25 February 2013

Mr Chris Ritchie
Team Leader – Industry Projects
Department of Planning and Infrastructure
GPO Box 39
SYDNEY NSW 2001

**Subject: Villawood Soil Remediation Project
Project Approval 09_0147
Modification Request 1**

This is consistent with the EA Figure 7, reproduced below.

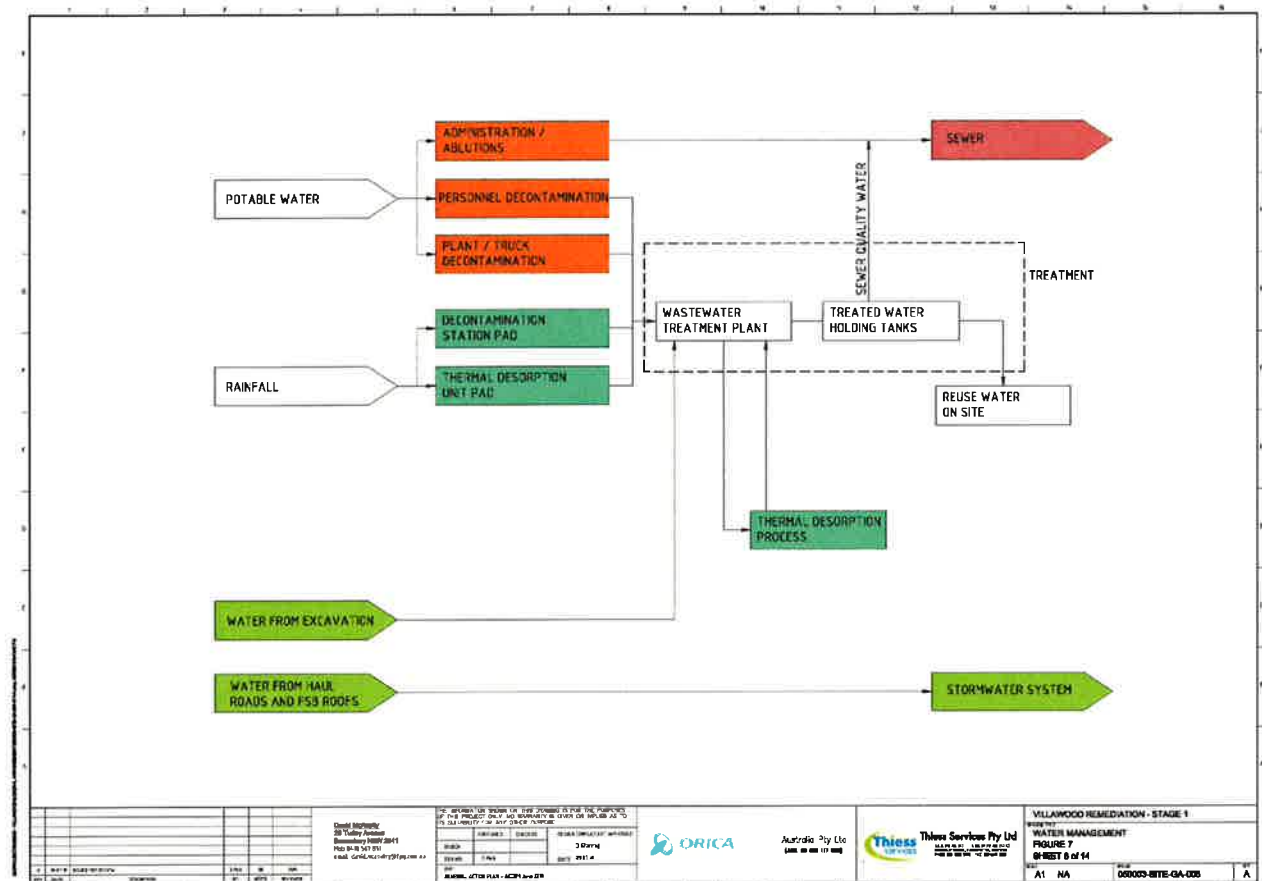
Figure 7 is a conceptual diagram. In order to be able to construct an appropriate water management facility, it is necessary to evaluate the potential volumes of water to be collected and processed and then to design a practicable project solution, which includes means of managing the various flows to and from the wastewater treatment plant.

The large volumes of the storage tanks – up to 1,600 m³ – and other constraints and considerations mean the most practical way of providing this capacity is in in-ground tanks in the form of clay- and HDPE-lined ponds.

This is not inconsistent with the EA. While Figure 7 refers to holding tanks, ponds are tanks by another name and the Remedial Action Plan, Appendix D of the EA, Section 16.2.3 suggests that storage before discharge could be in the form of a pit.

For reasons of practicality, sustainability and cost, Orica proposes to use in-ground, clay- and HDPE-lined ponds for water storage.
